**TOWN OF OCEAN RIDGE
PLANNING & ZONING REGULAR MEETING
AGENDA**

To:	Planning & Zoning Board Members
From:	Corey O’Gorman, Town Planner
Meeting Date:	July 21, 2026
Subject:	5920 N Ocean Blvd – Development Plan Review

PLAN REVIEW REPORT
5920 N Ocean Boulevard
05/06/2026 – 06/04/2026 – 07/14/2026

ASIR RESIDENCE
MAY 2026 TOWN PLANNER COMMENTS — COMPLIANCE RESPONSE
03 / 08

1/27/26

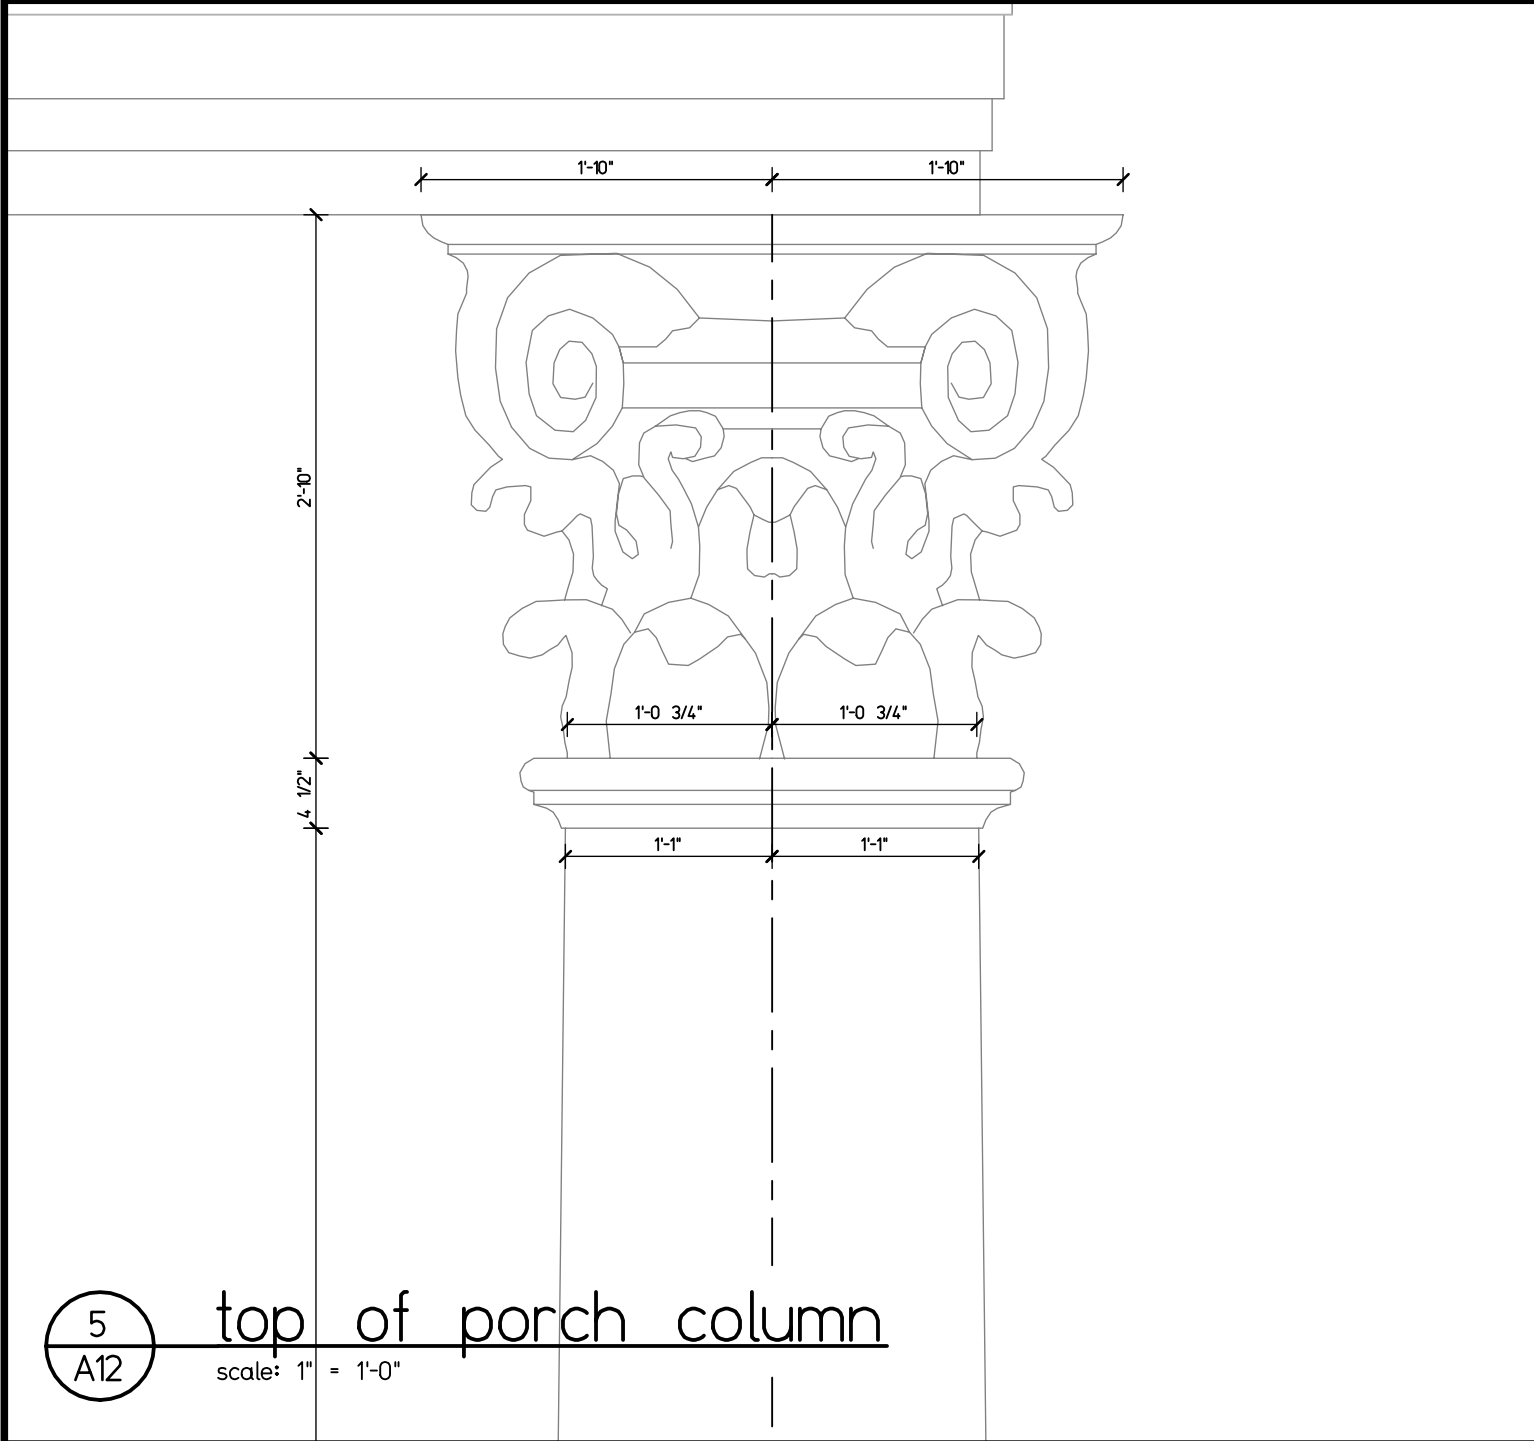
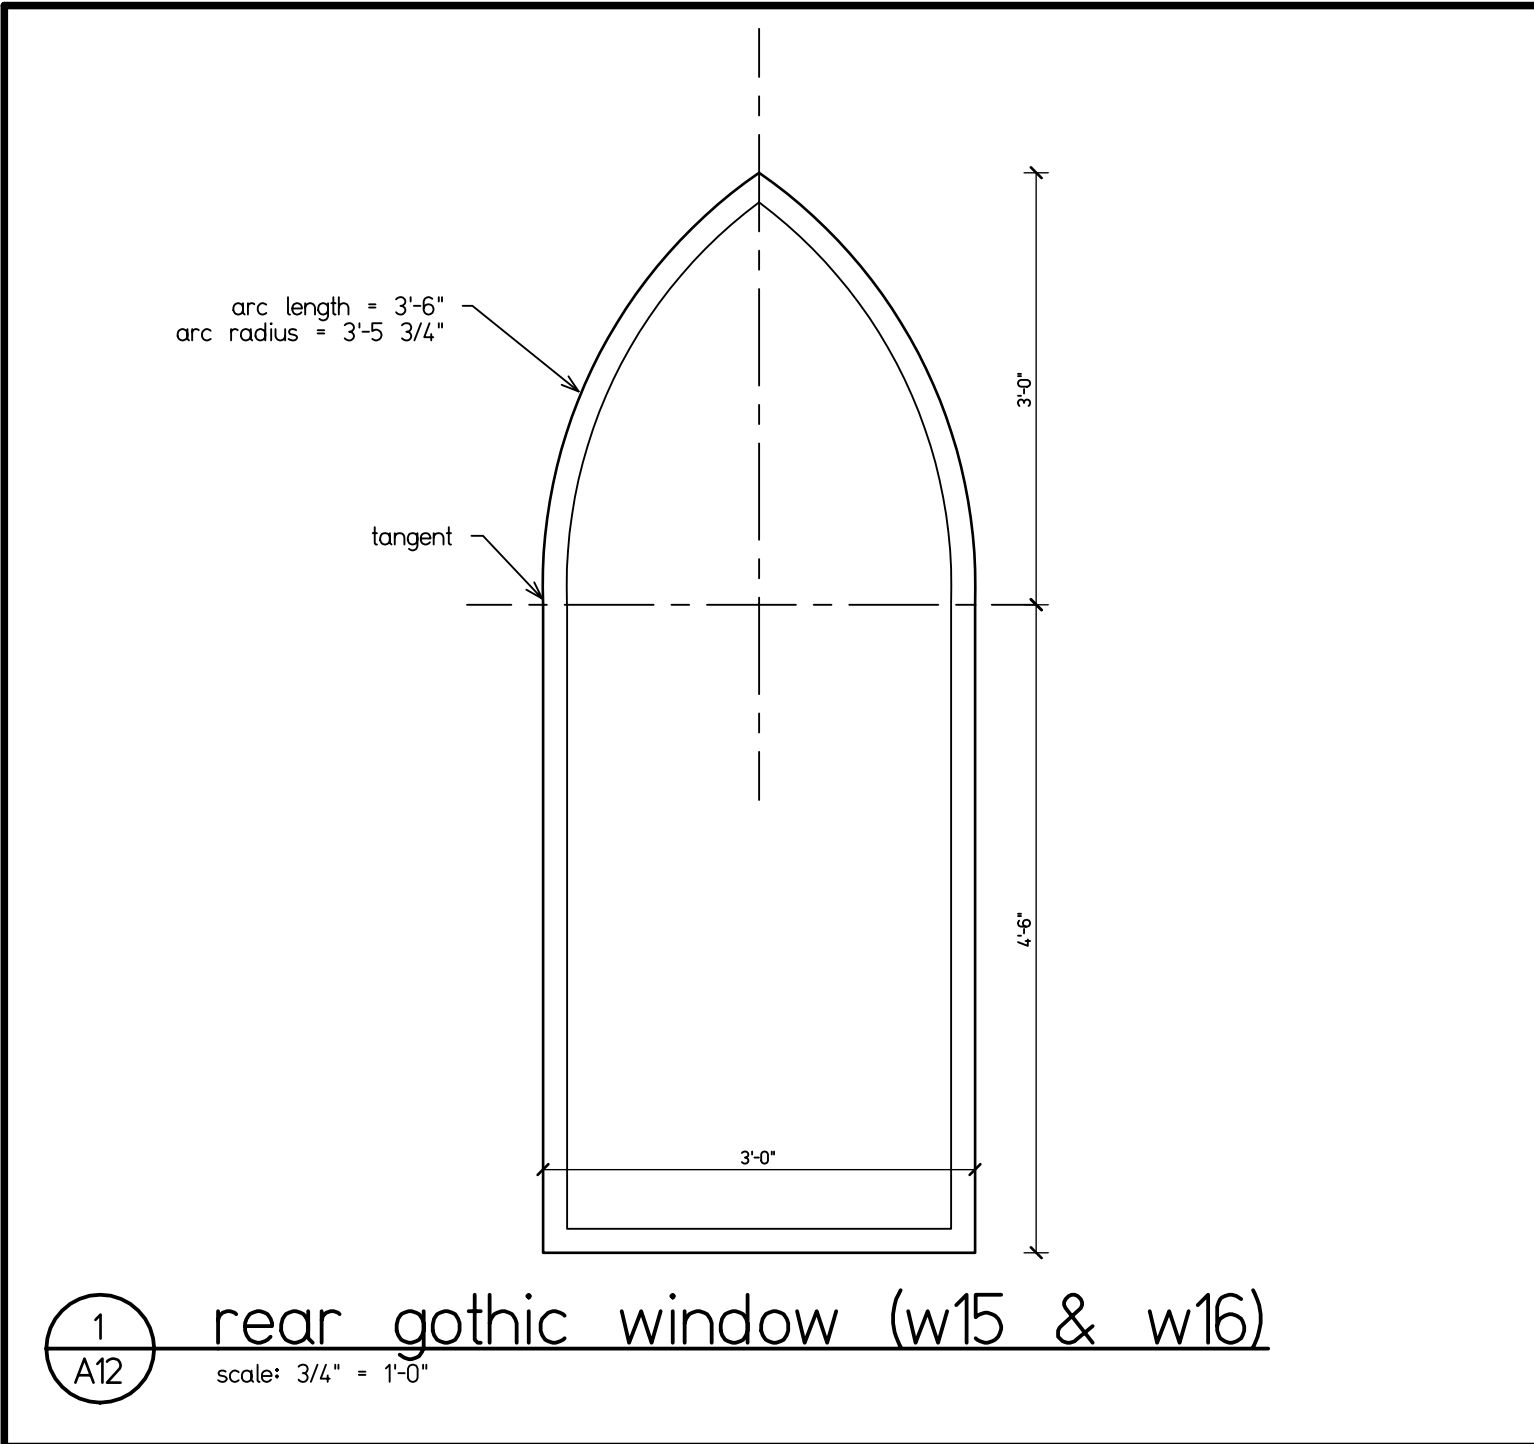
~~Comment: Please revise elevation sheets A11 and A12 to provide the calculations necessary to ensure compliance with the 15% requirement.~~
Comment addressed.

Comment: Please revise sheets A11 and A12, and other sheets as applicable to comply with the maximum height requirements in this code section. ~~Comment not addressed. As noted above, Section 64-1(f)(2) allows flat roofs provided that they comply with the requirements of Section 67-37. Section 67-37 limits the tie beam to 24' and requires a parapet which shall not extend more than 32" above the tie beam to screen any rooftop element as such the maximum overall allowable building height for a flat roof is 26' 8".~~

Calculations have been added directly to elevation sheets A11 and A12, confirming that all four building elevations meet or exceed the required 15% window and door opening coverage.

The north elevation has been revised accordingly. The proposed window trim, door trim, and decorative emblem do not extend beyond the plane of the existing encroachment wall. Articulation is achieved through recessed banding and stucco score lines flush to the wall face. Revised sheets A11 and A12 reflect this treatment.

Sheet A 0.2 — Existing & Proposed Landscaping with Tree Schedule

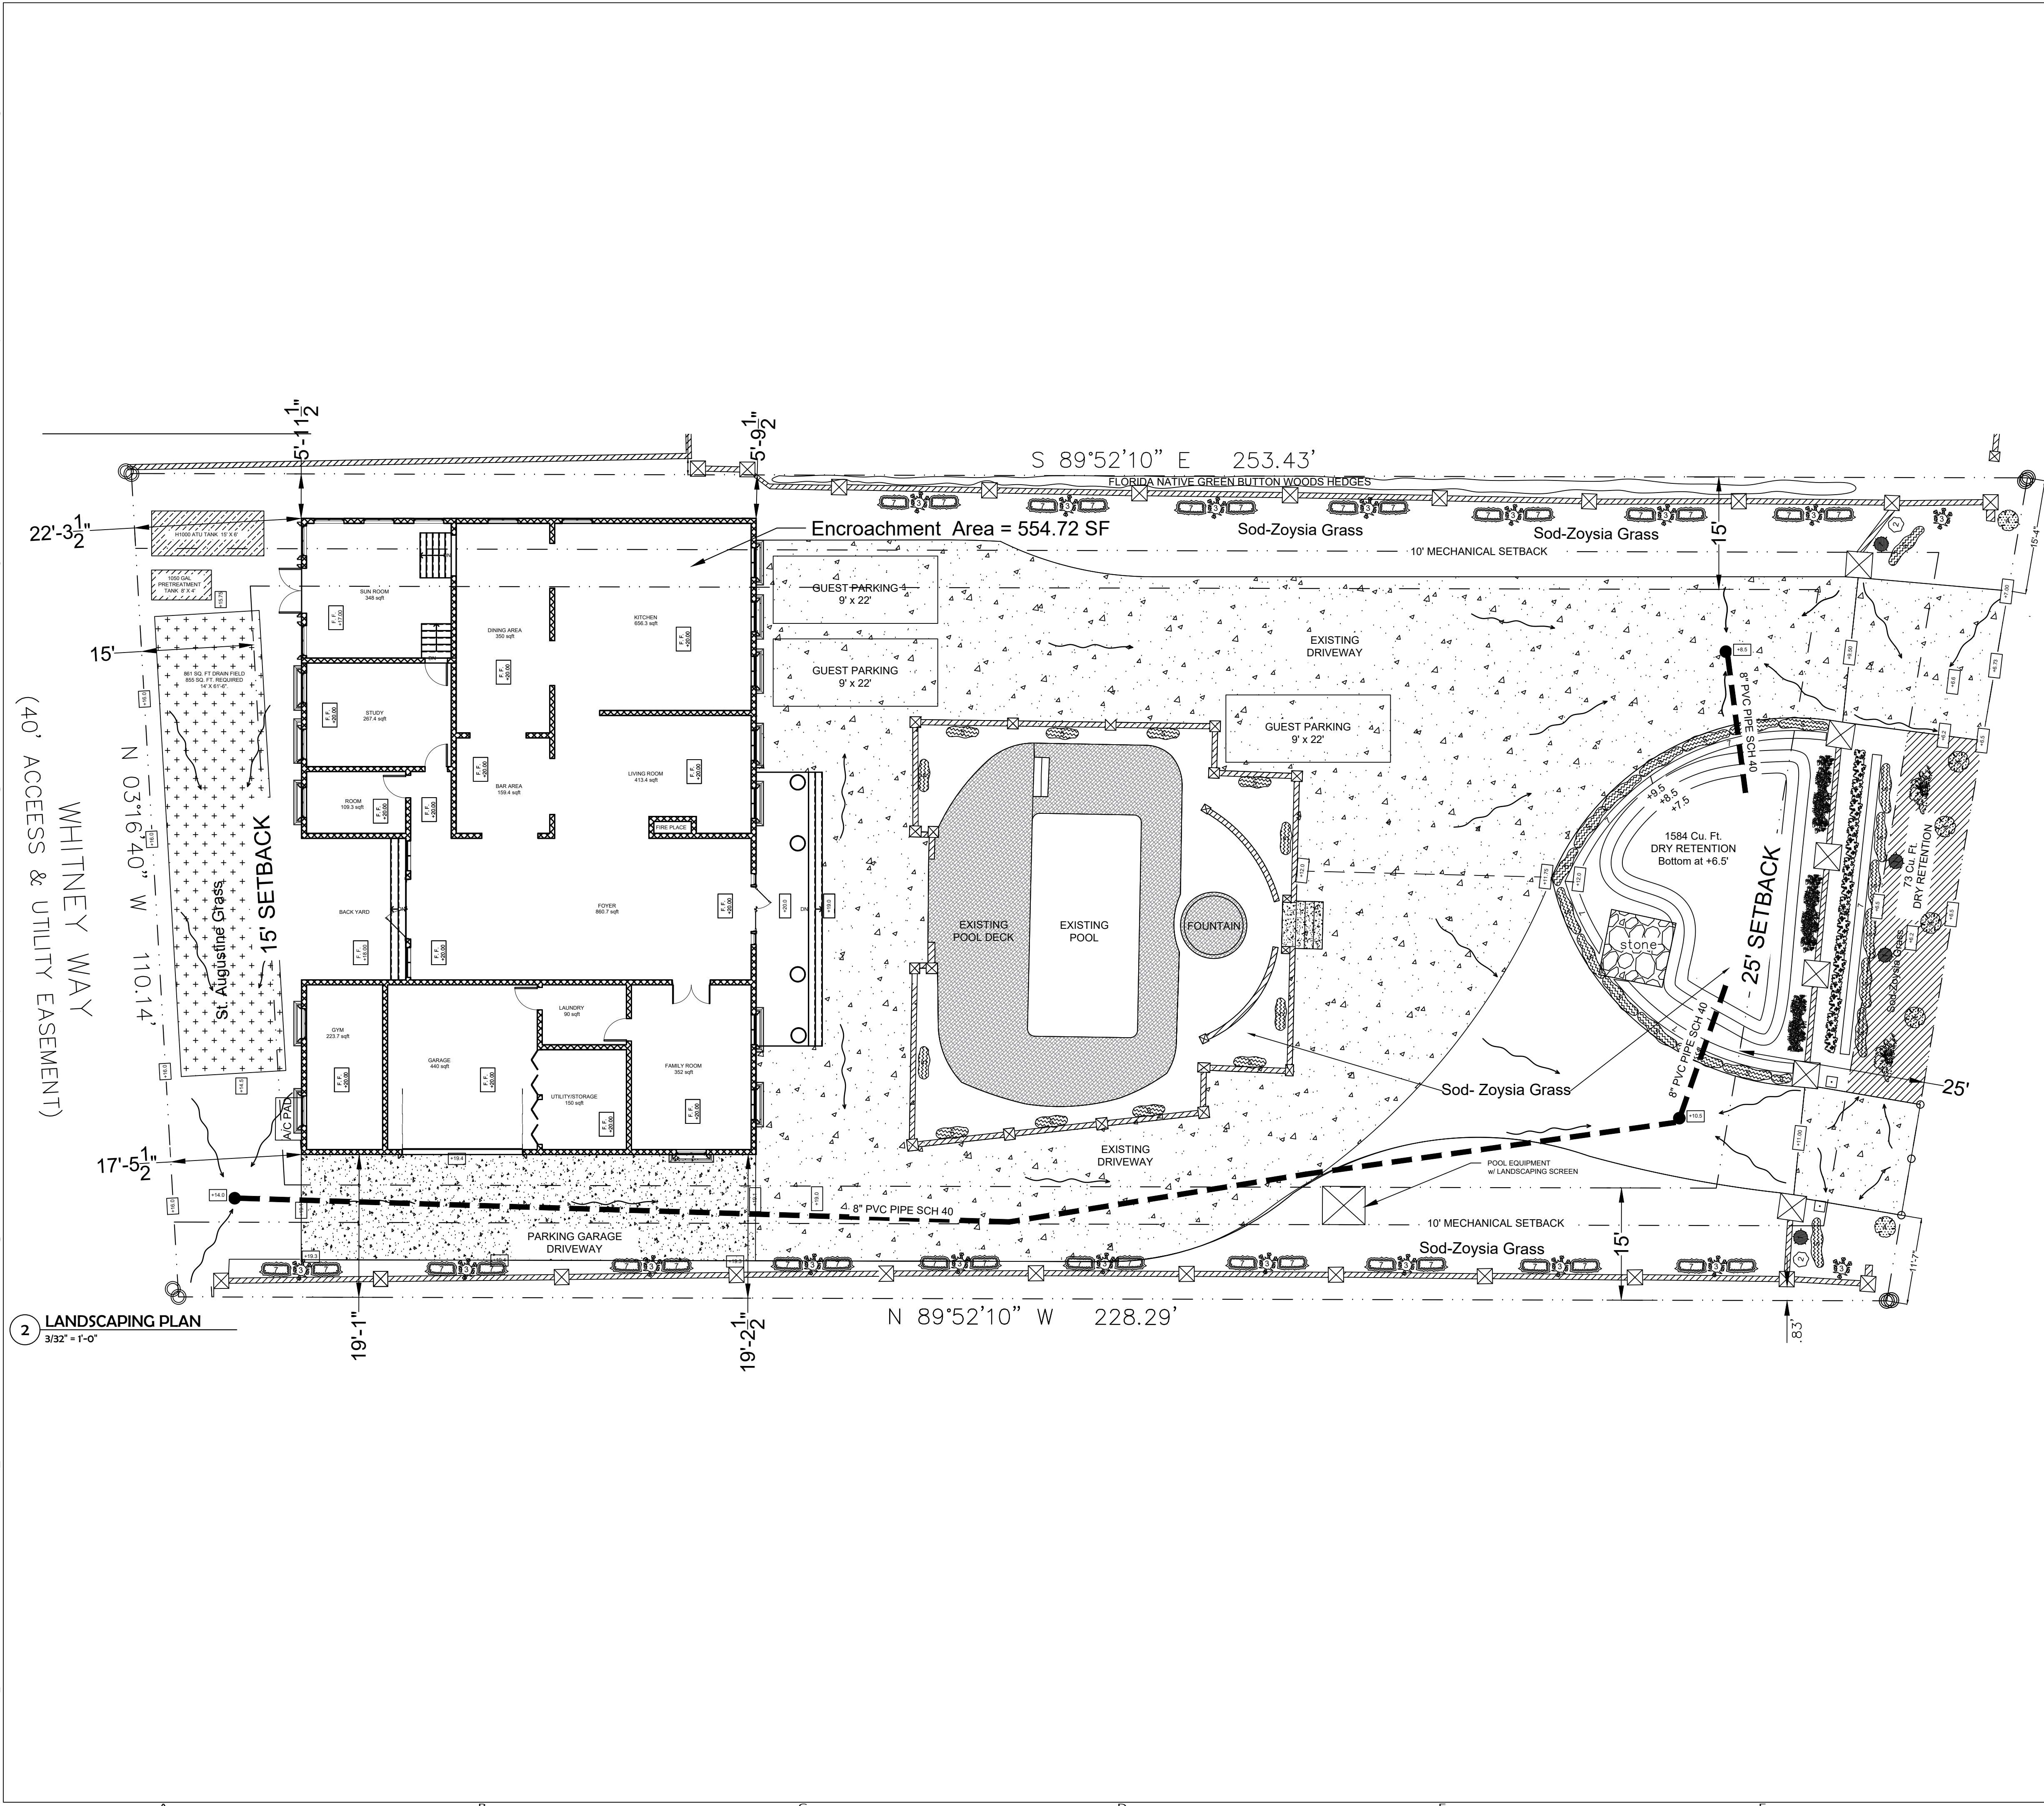
~~Comment: Please revise all applicable plans to show compliance with the 10' setback for mechanical equipment.~~ **Comment addressed.**

All mechanical equipment — AC condensing units, pool equipment, and generator — is shown on the site plan (Sheet A05), drainage plan (Sheet A0.3), and landscape plan (Sheet A0.2). Landscaping screening is provided on the landscape plan for all equipment locations. AC units have been relocated to the west side to comply with the 10' setback requirement of § 64-50.
